## Development Review Division

### MEMORANDUM

**TO:** Ryan Amato, EVT Parker Colorado, LLC  
**FROM:** Ryan McGee, AICP, Associate Planner  
**DATE:** October 27, 2017  
**SUBJECT:** 1<sup>st</sup> submittal of Site Plan for Parker Auto Plaza Filing No. 1, Block 3, Lot 1 (Planning Case No. SP17-073).

SP17-073; Parker Auto Plaza Filing No. 1, Block 3, Lot 1

Sheet Title:  
**SITE PLAN COVER SHEET**

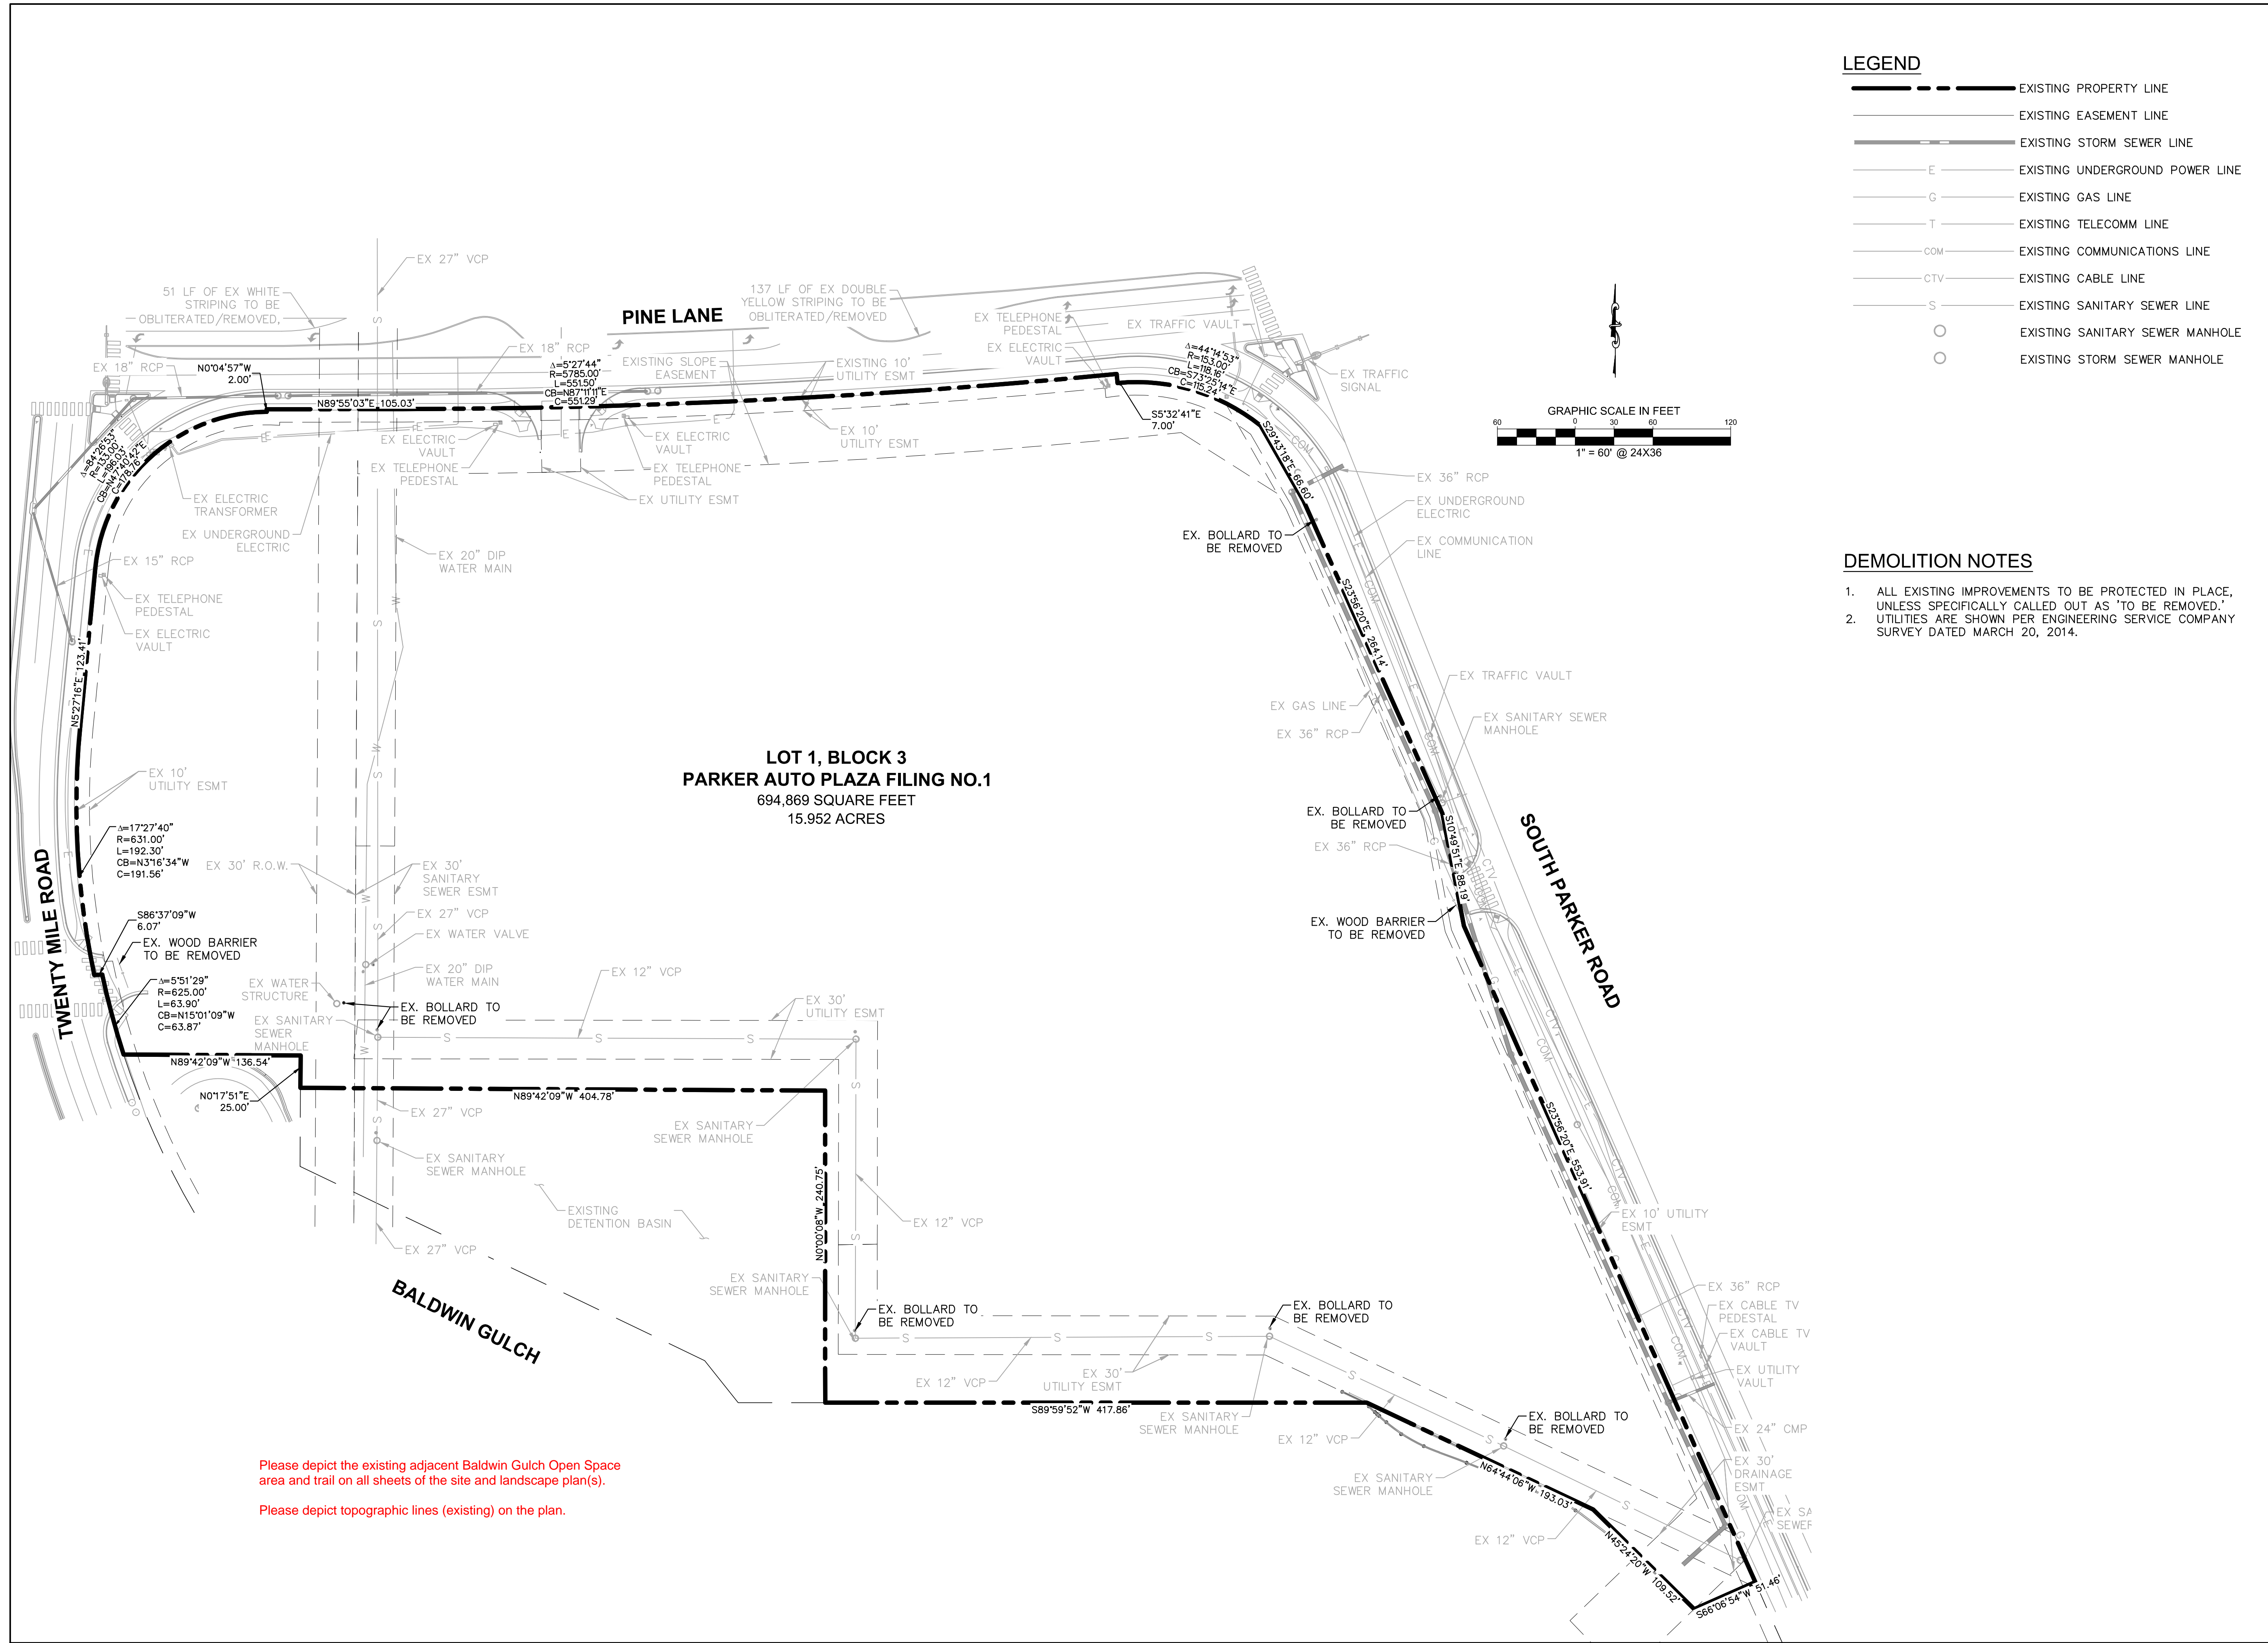
1. Please remove the "Proposed Zoning" from the Land Use Data table.

2. Fifteen (15) sheets are included in the site plan set submitted (not 16 Sheets). Please correct this and accurately (re)number the site plan set and sheet index.

3. The building height(s) depicted in the development standards table is inconsistent with the building height depicted on the building elevations. Please correct this.

4. Please remove the "Loading Area required and provided" from the site data table.

5. Please add the following from the Parker Auto Plaza PD Zoning: 1.) The Floor Area Ratio (FAR) requirement: 0.35 and 2.) The proposed FAR to the site data table.

6. **A minimum of 44 parking spaces are required for the proposed retail buildings. Please correct the site data table to reflect this.**

7. **Please add the Parker Auto Plaza PD required setbacks to the Land Use Data Table.**

8. **Please provide a written rationale (or information related to the intent) for why vehicle parking for the entirety of the site is being depicted with this submittal. Please note that given staff's current understanding of the intent of the parking, staff does not support depicting vehicle parking for entirety of the site with this submittal. Depicting vehicle parking on the entirety of the site implies partial approval of future site plans and limits flexibility for improving the overall site layout and organization.**

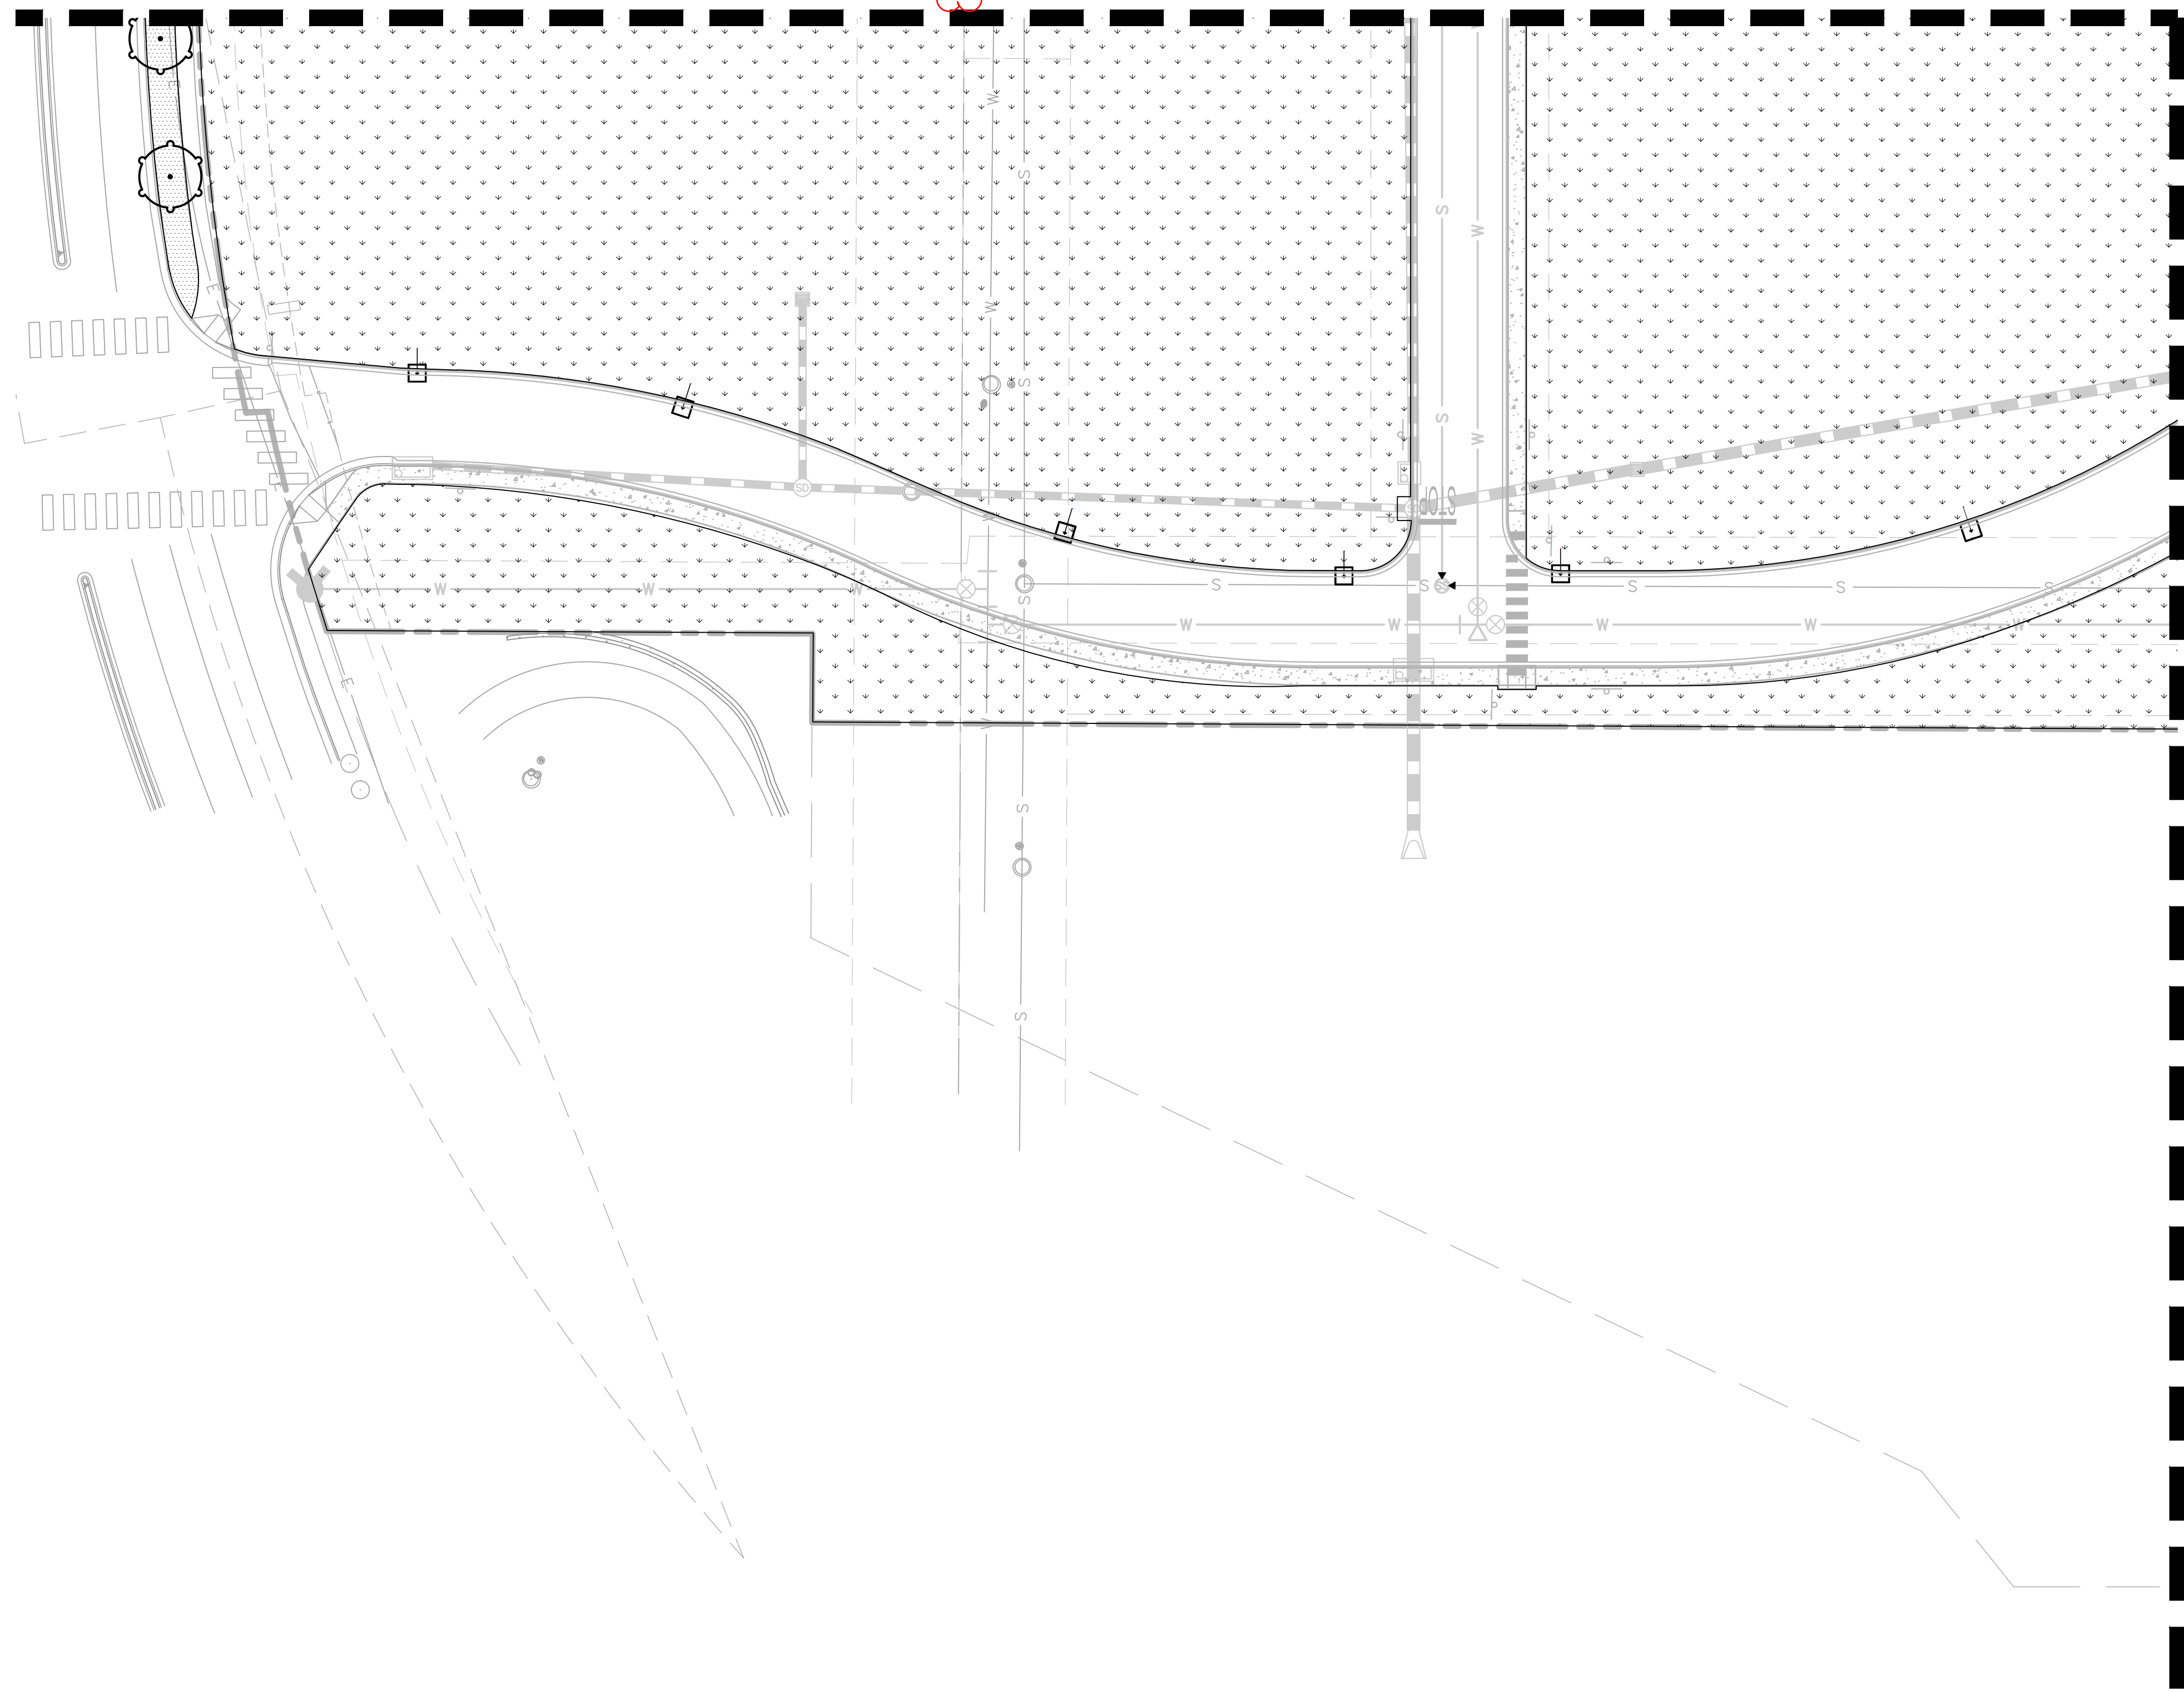
Incorrect. Please correct.

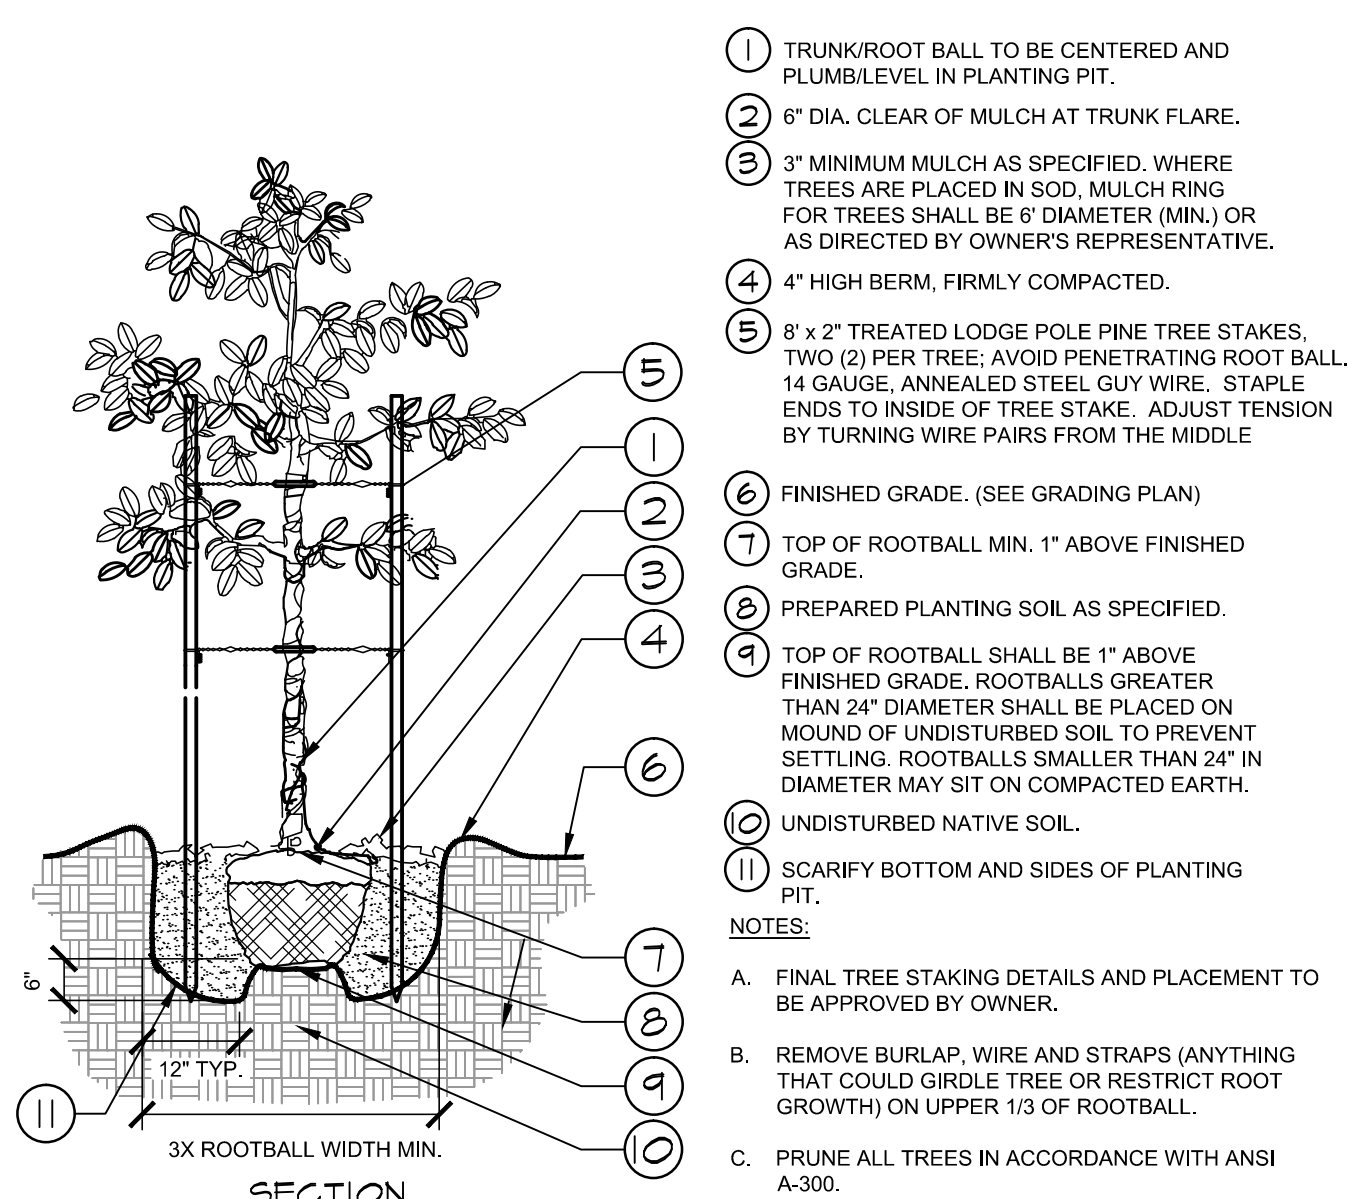
Traditional turf grasses shall only make up fifteen percent (15%) of any required on-site landscaping (15,635 s.f.) for commercial uses.  
Please amend the landscape plan and plant schedule to meet this requirement.

3 EAST ELEVATION RETAIL B  
1/16" = 1'-0"

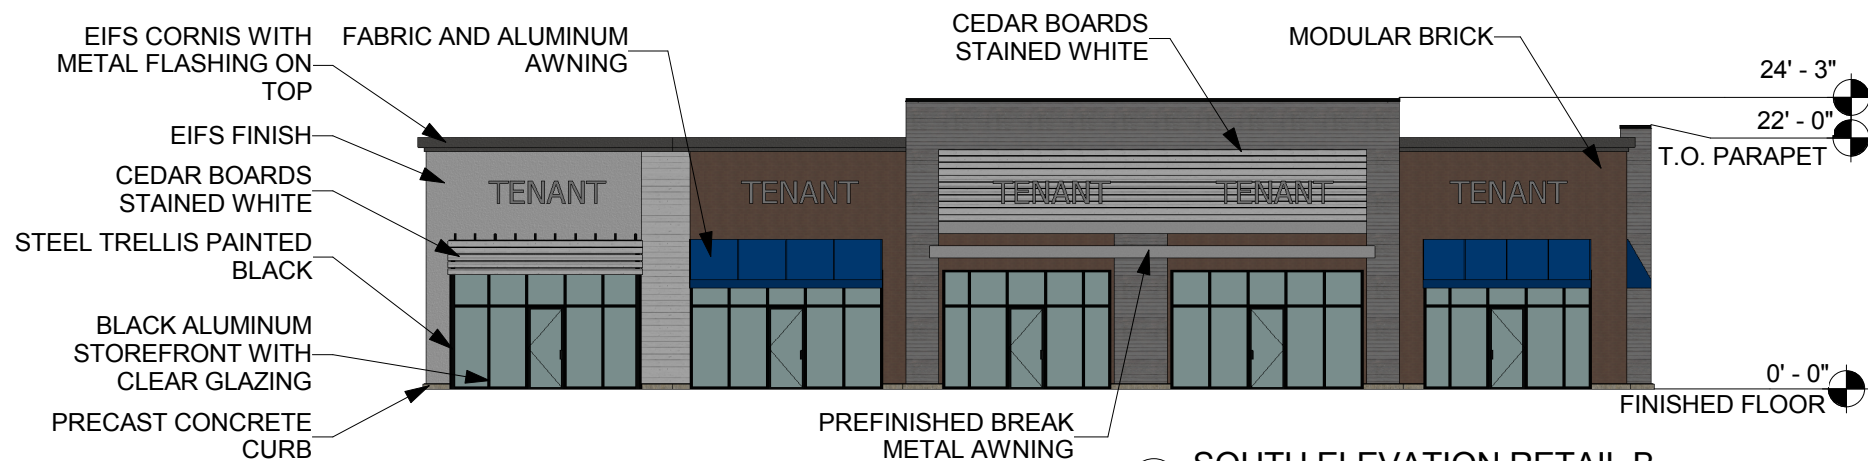
- 20. The site plan is inconsistent with the building elevations. The site plan omits two (2) trellises proposed between the Retail A and retail B buildings.

**Please depict the two (2) trellises proposed between retail buildings A and B on the site plan.**

Please depict the 2 trellises proposed between the buildings.
